Access Compliance Report

Public Rights-of-Way (Curb Ramps)

| Intersection ID: 45240 | Main Street: BEGONIA_DR | Cross Street: BLAZE_MANOR_LN | Location: W |
| ADA ID: 52F0F0CC4AAE | Ramp Type: PerpDiag | Initial Pass/Fail: Fail | Overall Compliance: No |

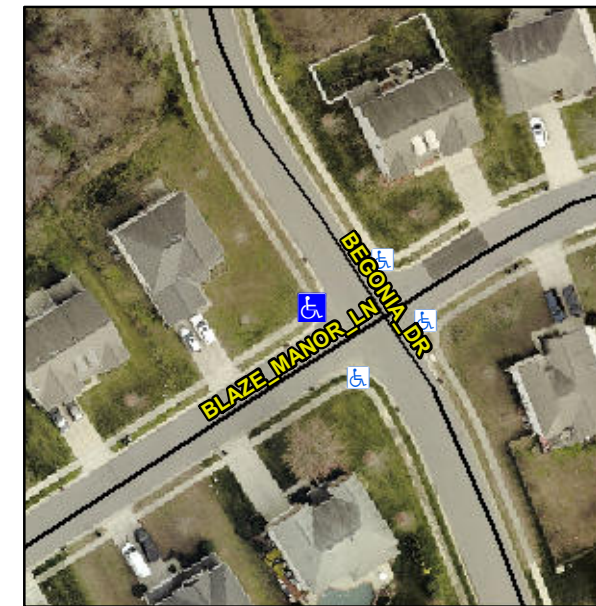
Not Found, R304.5.1, R304.2.2

| Compliance | Description | Data | Compliance | Description | Data |
|------------|-----------------------|-------|------------|-----------------------------|-------|
| N/A | Ramp Length (in) | 47.0 | No | Ramp Slope (%) | 9.0 |
| No | Ramp Width (in) | 47.5 | Yes | Ramp XSlope (%) | 1.9 |

Remove & Replace Curb Ramp With Two New Directional Ramps or Equivalent.
